THE REGIONAL MUNICIPALITY OF YORK

ADDENDUM #3

BID # RFTC-2623-25-C24073

FOR: York Region Administrative Centre Renovation - Package E

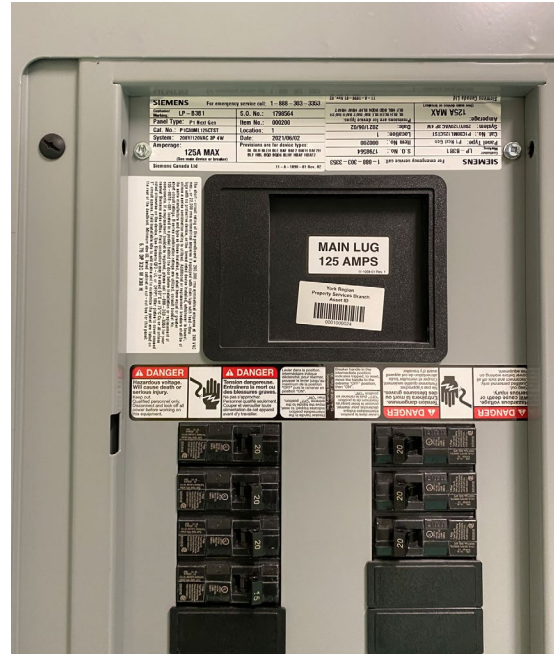
We are currently in the process of reviewing the project plans. However, we have noticed that there is no available information regarding the fire alarm system requirements. Specifically, we are unable to locate the fire alarm panel, as well as there is no fire alarm single-line diagram provided.

In addition, we kindly request information on the make and model of the existing electrical panel so that we can provide an accurate price for the required loose breakers.

Fire alarm panel located in Building Operators Office in Level P1 of Block D, see snip below.

For the scope of a tenant fit-out, we believe fire alarm single line is not necessary.

Existing electrical panels include: Federal Pioneer, Square D, and Siemens. Photos attached for reference.
